Technical Bulletin

GX/HX BLOWER SHIPPING BRACKET

Tech Bulletin #: TB10.002

REMOVAL OF SHIPPING BRACKET

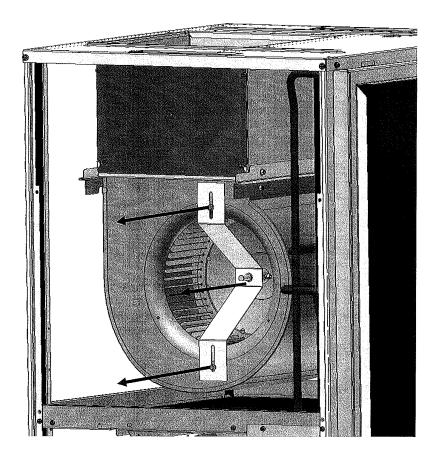
Enertech Manufacturing has added a blower shipping bracket on the opposite side of the blower motor that needs to be removed before start up. *This only applies to Compass and Revolution vertical units.*

The attachment shows the location of the shipping bracket.

THIS BRACKET MUST BE REMOVED.

Remove the two (2) screws shown and then slide the shipping bracket off the motor shaft before unit start up. Dispose of the bracket and the screws.
